# REPAIR MANUAL

BRONICA CO., LTD.

Date: October 1985

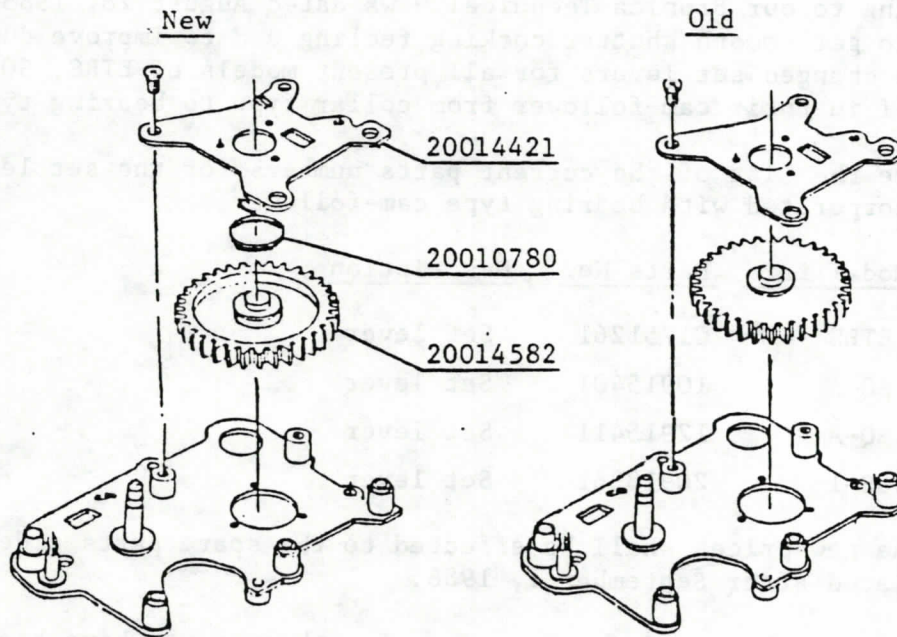
Revised Parts:

<u>Parts No.</u>	<u>Description</u>	<u>Remarks</u>
20010780	Friction spring	Newly added
20014421	Winding holder	Groove for spring hook installed
20014582	G2 gear	Appearance change

In relation with this revision, 20010770 friction spring shall not be used any more.

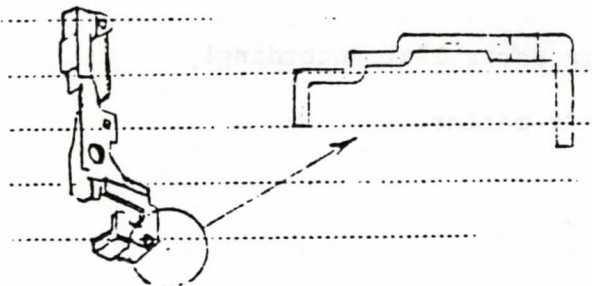
<u>Description</u>	<u>New Part #</u>	<u>Old Part #</u>
AE Switch Cover	01253727	01253726

Please change Parts Numbers on your parts list accordingly.

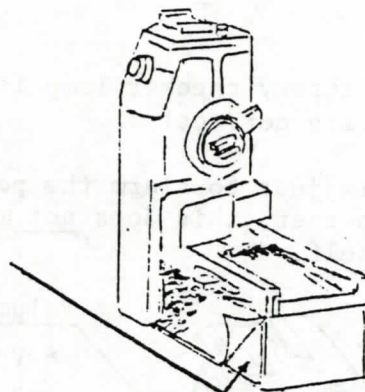
Ref : Change of Motor for Motor Drive E for ETRS

The Price of the motor remains unchanged.

In this connection, we newly put the identification mark on Motor Drive E which carries new motor as follows :

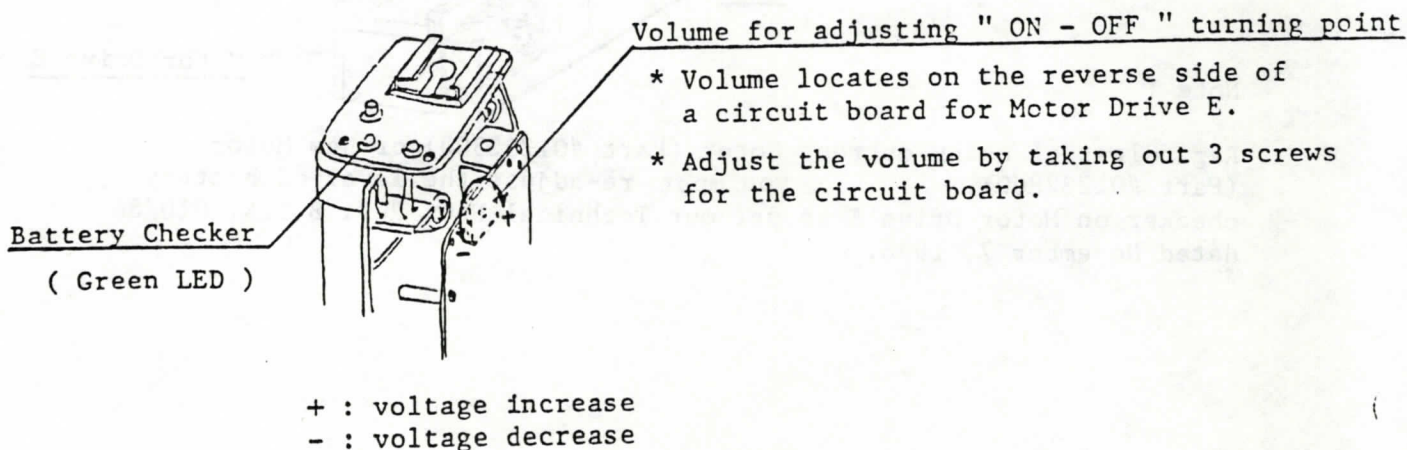
Ref : Change of " ON - OFF " turning point of Battery Checker on Motor Drive E

Even though the battery checker lamp is not " ON ", winding and release function may operate correctly.

This changement is just to alarm the power down of battery a little earlier than before. However, this does not mean the lowering of capacity of Motor Drive E itself.

Light Shield Operating Lever (Part #20918190)

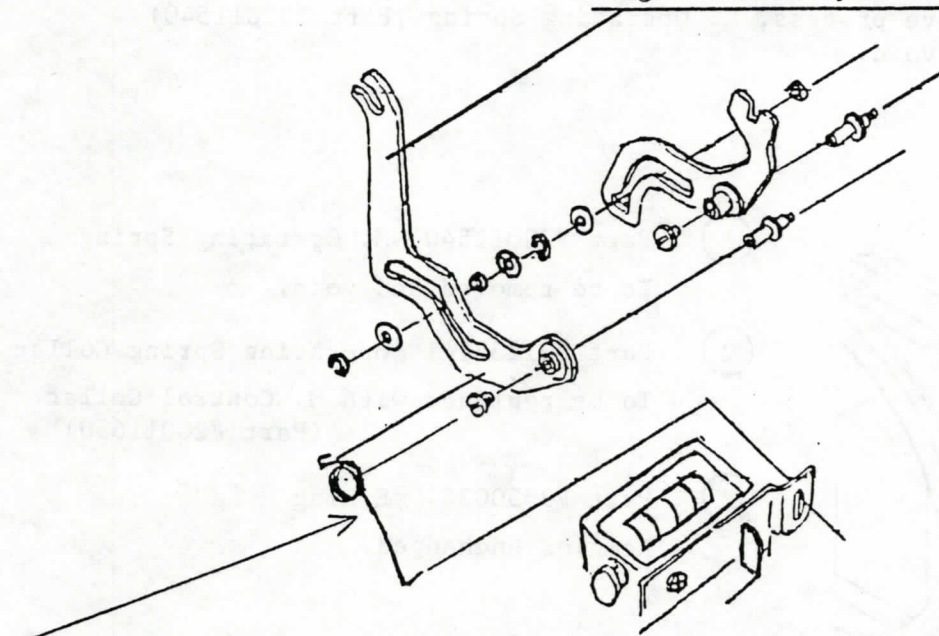
To make the function of shutter release more smoothly while the mirror locked-up, we newly added a spring ( Light Shield Operating Lever Spring, Part #20011660) to the Light Shield Operating Lever (Part #20918190) for GS-1 Main Camera Body.

<u>Description of New Part</u>	<u>Part #</u>
Light Shield Operating Lever Spring	20011660

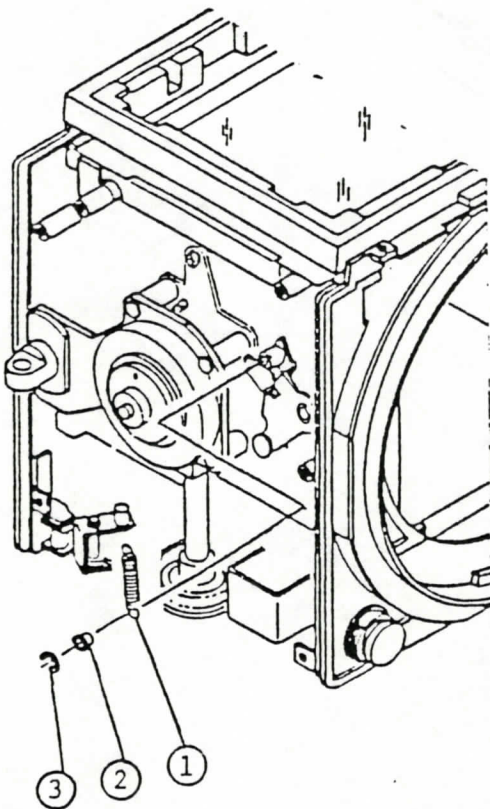
To decrease mirror-shock on GS-1 body, we have modified and/or newly added following parts for GS-1 Main Body.

<u>Item Description</u>	<u>New Part #</u>	<u>Old Part #</u>
Winding Chamber Unit	20915103	20915102
M. Control Collar	20011650	-----

When the old Winding Chamber Unit (Part #20915102) will be replaced with New one (Part #20915103), Operating Spring Collar (Part #01252141) should also be replaced with M. Control Collar (Part #20011650). In addition to the above process, M. Operating Spring (Part #20011540) should be removed and void.

New Type

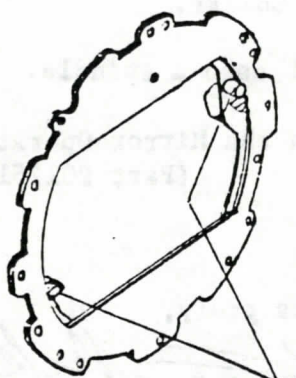
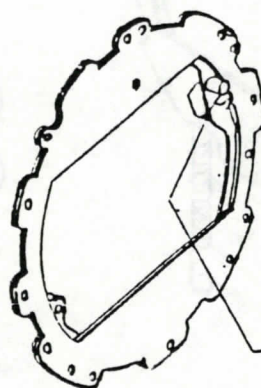
In order to reduce the torque when winding the crank and also to improve the durability, a change has been made to a system so as to set the lens by 2 pins on right and left. A new lens set pin has been added also on the right side in addition to the present left side lens set pin.

New shutter operating ring unit and the old shutter operating unit are interchangeable.

Subject : Change of Left Cover set 02910231

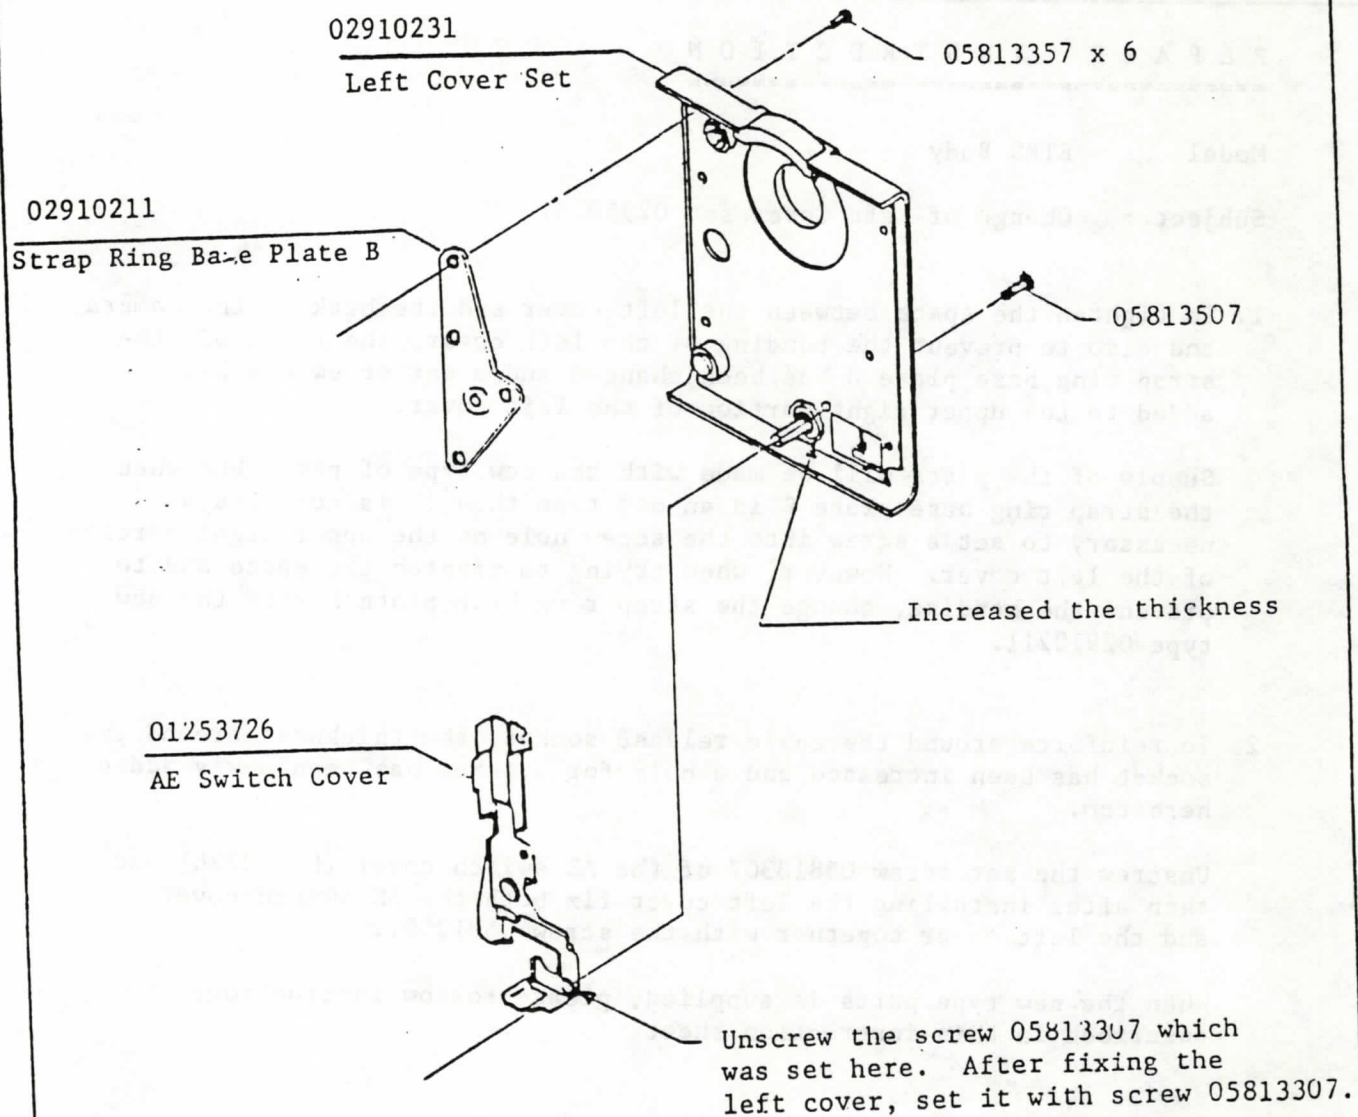
1. To tighten the space between the left cover and the back of the camera and also to prevent the bending of the left cover, the shape of the strap ring base plate B has been changed and a set screw has been added to the upper right portion of the left cover.

Supply of the parts will be made with the new type of parts but when the strap ring base plate B is an old type then it is not always necessary to set a screw into the screw hole on the upper right portion of the left cover. However, when trying to tighten the space and to prevent the bending, change the strap ring base plate B with the new type 02910211.

2. To reinforce around the cable release socket, the thickness around the socket has been increased and a hole for a screw has been newly added here too.

Unscrew the set screw 05813307 of the AE switch cover (01253726) and then after installing the left cover fix both the AE switch cover and the left cover together with the screw 05813507.

Subject : Adding a Set Screw on the Right Cover 02010133  
Change of fixing method of Film Back Coupling Claw

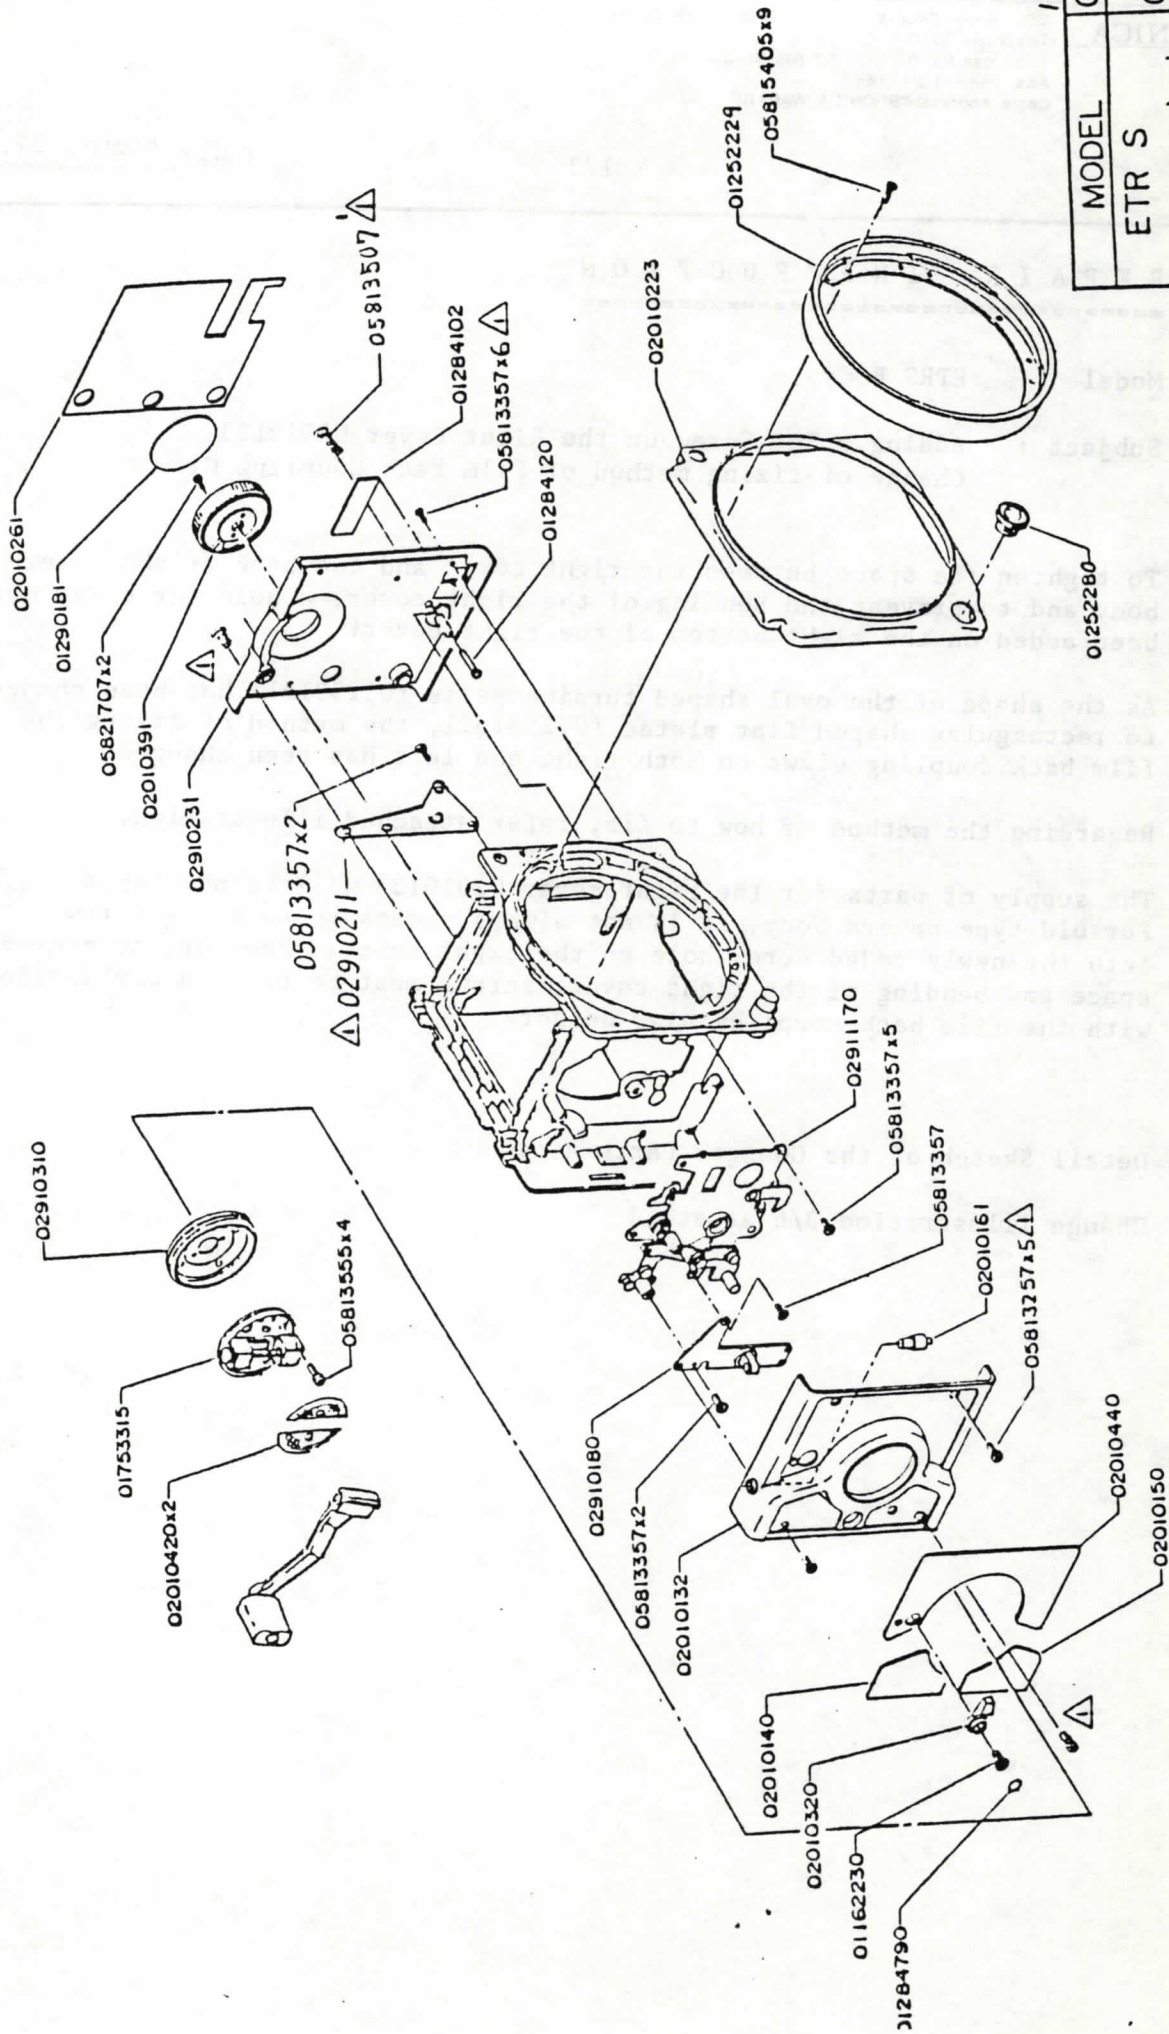
To tighten the space between the right cover and the back of the camera body and to prevent the bending of the right cover, a hole for screw has been added on the right bottom of the right cover.

Regarding the method of how to fix, refer attached illustration.

The supply of parts for the right cover 02010133 will be new types. For old type camera body, it is not always necessary to set a screw into the newly added screw hole on the right cover. However, to prevent space and bending of the right cover, screws must be used in combination with the film back coupling claw holder.
